**DOCKET NO: A-98-49
II-B1-16**

**TECHNICAL SUPPORT DOCUMENT FOR SECTION 194.23
REVIEW OF THE 2004 COMPLIANCE RECERTIFICATION
PERFORMANCE ASSESSMENT BASELINE CALCULATION**

**U. S. ENVIRONMENTAL PROTECTION AGENCY
Office of Radiation and Indoor Air
Center for the Waste Isolation Pilot Plant
1310 L St., NW
Washington, DC 20005**

March 2006

Figure 6-1. Initially Anaerobic, Amended Humid Experiments
(Gillow and Francis 2003)

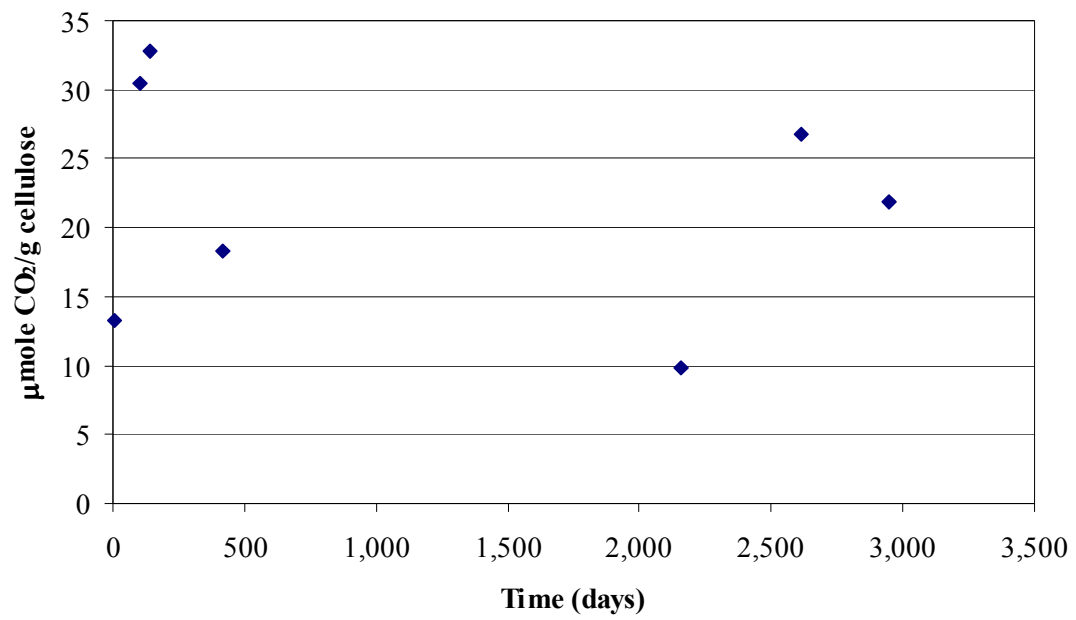
Nemer et al. 2005 used data from the unamended experiments to determine the maximum long-term gas generation rate under humid conditions. The reasons for excluding data from the humid amended experiments were not stated. However, examination of the data reported by Gillow and Francis 2003 shows that the long-term rate for the humid amended experiments was essentially zero (Figure 6-1), and the lower limit for the humid gas generation rate was assumed to be zero by Nemer et al. 2005. The Agency successfully reproduced the calculation of the maximum long-term humid gas generation rate using the same carbon dioxide data as Nemer et al. 2005 (Appendix C). The assumption that the humid gas generation rate would range between this maximum rate and zero as observed in the amended humid experiments is consistent with the available experimental data.

Figure 7-1. Felmy et al. 1991 ThO₂(am) Solubility Data Difference Value Histogram
 (Source: ASTP.2005.04A_Xiong et al, An Sol Unc, Rev 1, Spreads, 2 of 2.xls)
 This distribution was used to develop the +IV actinide solubility uncertainty for the PABC.

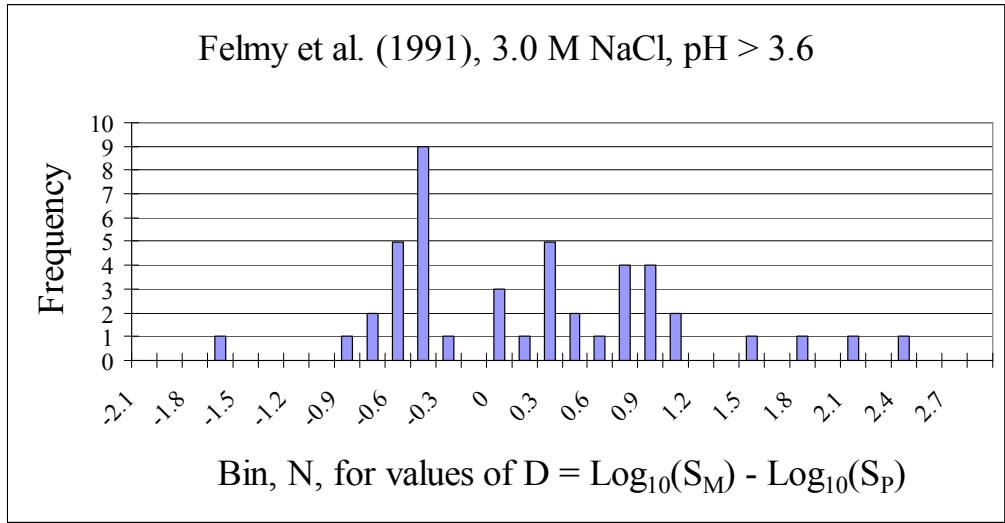
For example, the distribution of D values for the Felmy et al. 1991 ThO₂(am) data is illustrated in Figure 7-1. Even though the thermodynamic data for ThO₂(am) in FMT_050405.CHEMDAT were derived from this study, the range of difference values was relatively large, with D values that ranged from -1.75 to 2.39. The distribution is weighted somewhat toward positive D values, indicating that the model tended to more often underpredict measured solubilities. This example indicates that using data included in the development of the thermodynamic database may not result in a solubility uncertainty distribution that is closely grouped or symmetric around D values of zero. Therefore, in future determinations of actinide solubility uncertainty distributions, it would be advisable to include all available data, even if it was used to develop

Figure 8-5. The CRA-Revised (PABC) Full Mining Zones Overlaid with the 1996 CCA (red) and CRA delineations (blue)
 (Source: Lowry and Kanney 2005)

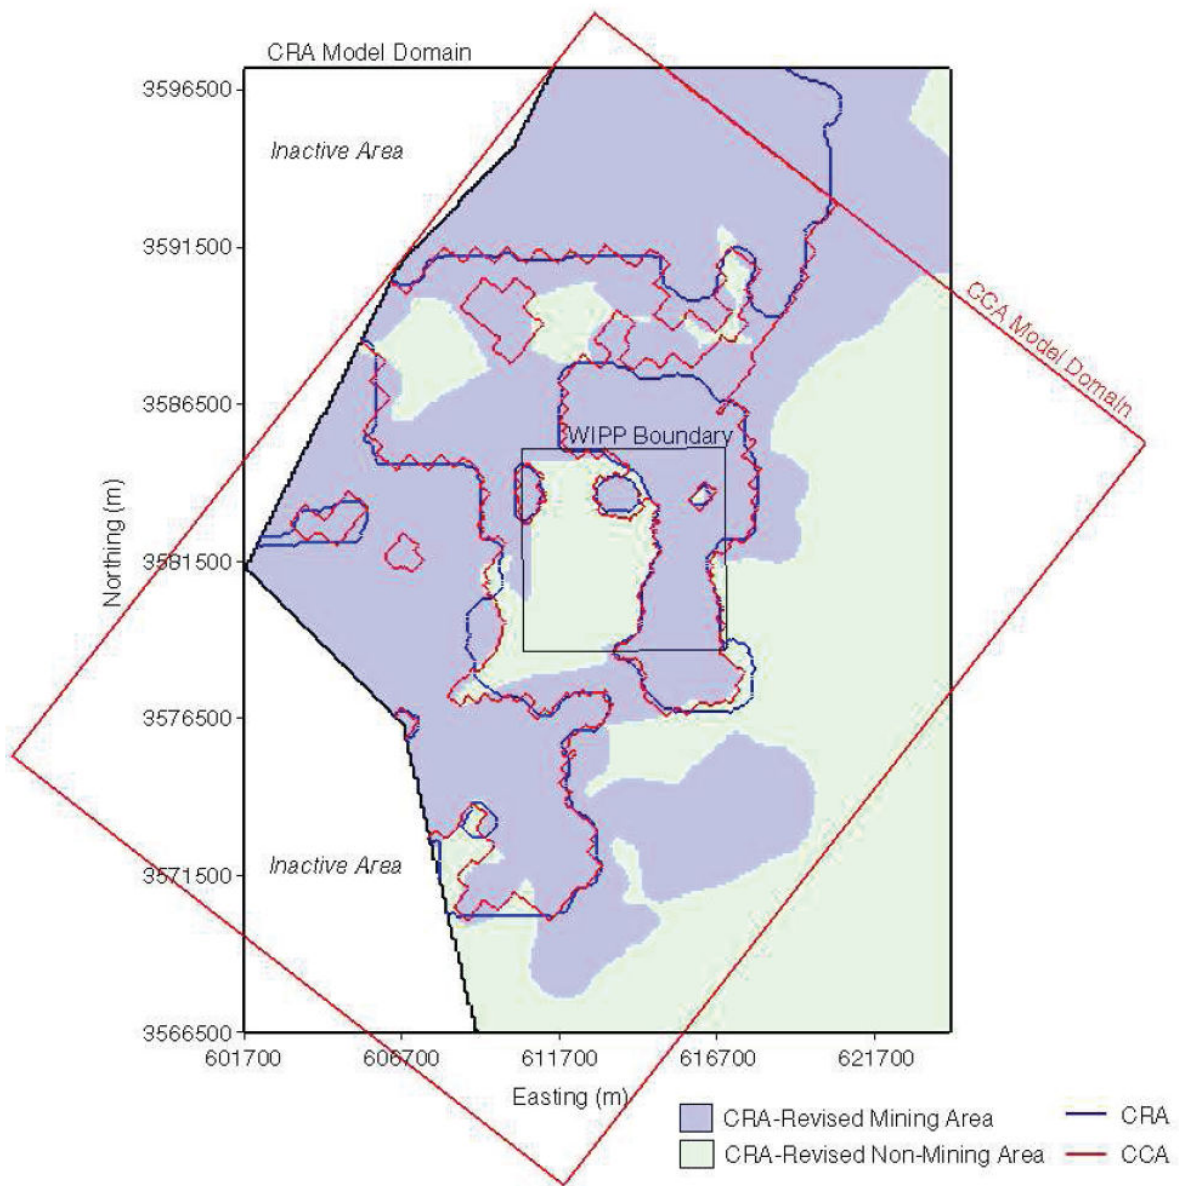
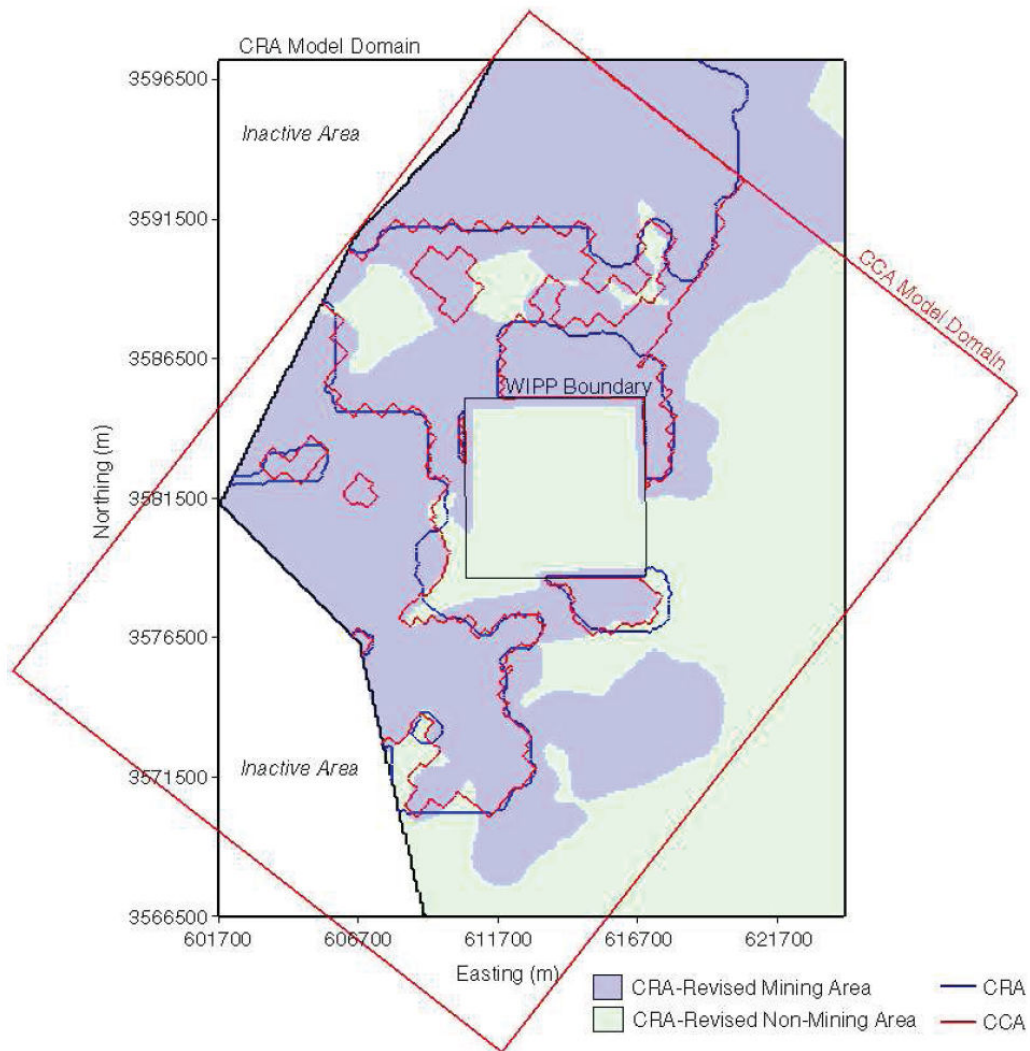
The model domains of the CCA grid, CRA grid, and the CRA-revised (i.e., PABC) grid for both the full- and partial-mining scenarios are shown in Figures 8-5 and 8-6, respectively. Results show that for both the full- and partial-mining scenarios, the median particle travel times of 75,774 and 129,202 years are 4.14 and 7.06 times longer than for the non-mining scenario (18,289 years). The increase in transmissivity due to mining increases the relative flow rate through the mining zones, with a corresponding decrease in flow through the non-mining zones. This decrease in flow through the non-mining zones produces longer travel times for the mining scenarios. Comparing the full-mining scenarios of the PABC analysis to the CCA and CRA calculations, the median travel times are approximately 2.53 and 1.14 times longer, respectively. For the partial mining case, the median travel time for the PABC is 9.33 times greater than the median for the CCA, and 2.67 times greater than the CRA. DOE attributes this increase in the travel time over the CRA to the higher percentage of area deemed as mining zone. DOE points out that unlike the CRA, a negative correlation was found in the PABC analysis between the travel times and the random mining factor (the higher the random mining factor, the longer the particle travel time). DOE believes this is also due to a higher percentage of mining zone area in the PABC analysis as compared to the CRA. With a higher percentage of mining area, the random mining factor has a larger influence on the regional flow regime. As the mining factor is increased, the flow through the non-mining areas is decreased, producing longer travel times and the negative correlation. However, additional analysis shows that most of the travel time variability is due to differences in the base T fields and not the random mining factor.

By eliminating the exclusion zone around the existing oil and gas wells the DOE has addressed the Agency's concern with respect to the mining scenario.

Figure 9-5. Schematic of the Stratigraphy Surrounding the Raised and Unraised Sections of the Repository
(Not to scale)
(Source: Stein and Zelinski 2003c)

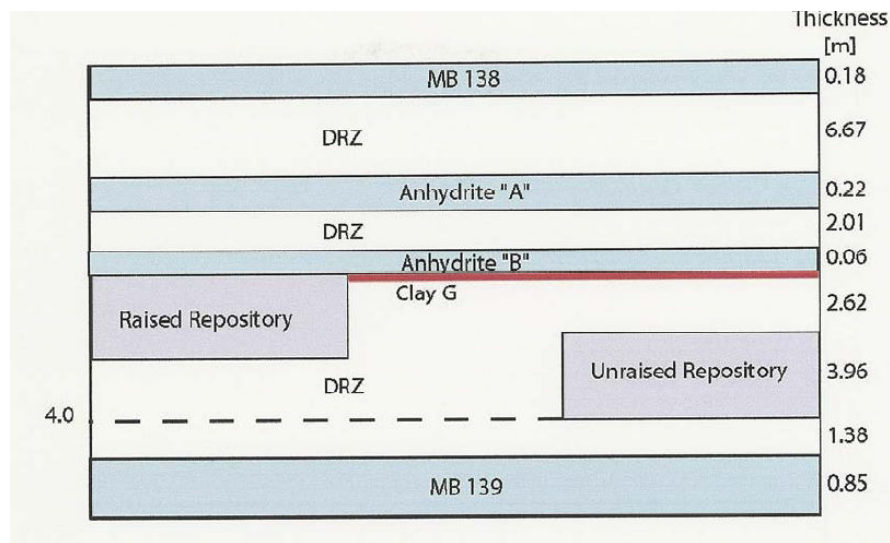
Figure 9-5 (Stein and Zelinski 2003c) compares the raised and unraised repository configurations in relation to the surrounding stratigraphy. In particular, in the raised half of the repository, the distance through the lower DRZ from the repository floor downward to MB 139 increases from 1.4 m to approximately 3.8 m. This change means that fracturing associated with floor heave will likely be reduced in this part of the repository.

that the parameters used by the BRAGFLO fracture model and applied to the Marker Bed materials and the DRZ are justified, because they do not allow repository pressures to significantly exceed lithostatic pressure.

The Agency believes that the processes should be modeled as realistically as reasonably practicable. Since the rock will fracture once lithostatic pressures are exceeded, the DRZ should be allowed to fracture. Furthermore, the pressure distribution within the repository should be relatively uniform at both the top and the bottom. Therefore, DOE's conceptualization that both the upper and lower DRZ's can fracture is appropriate.

Figure 10-2. Combined Mean DBR CCDFs for All PAVT and PABC Replicates
 (Source: Vugrin 2005h, Figure 4)

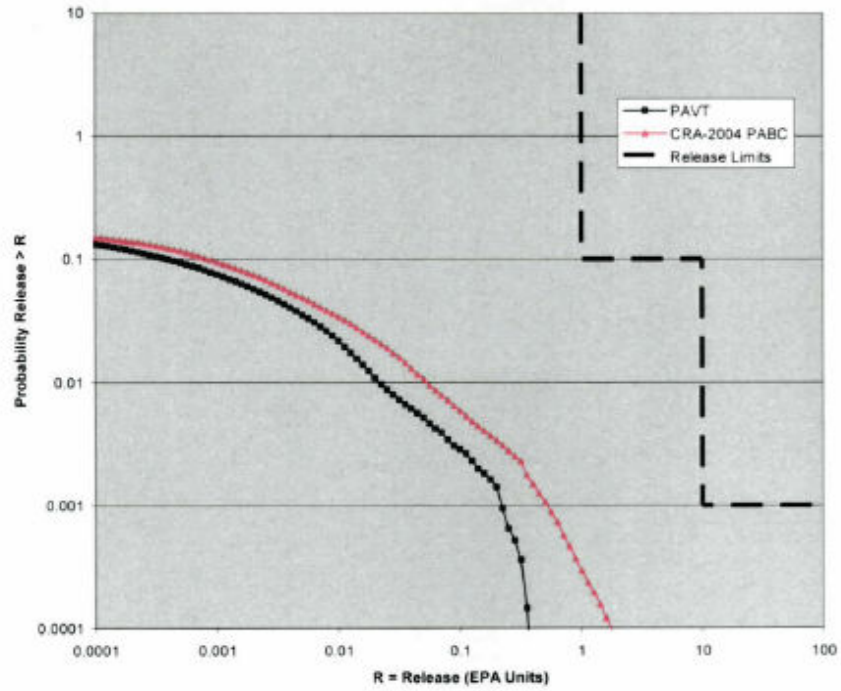
Figure 10-2 illustrates the differences between projected direct brine radionuclide releases for the PAVT and PABC. Comparison of these projections shows that the projected contribution of DBRs to total radionuclide releases has increased. The increase is most notable at probabilities less than about 0.002, where mean direct brine radionuclide releases have become the greatest contributors to total mean direct release in the PABC (see, for example, Leigh et al. 2005a, Figure 6-6). This is attributed primarily to changes in the PABC that increased actinide solubilities (Leigh et al. 2005a, Section 6.4). These changes included increased solubilities and revising the solubility uncertainty range (Leigh et al. 2005a, Sections 2.5 and 2.6). Given these changes, the calculated increase in DBR radionuclide releases is reasonable.
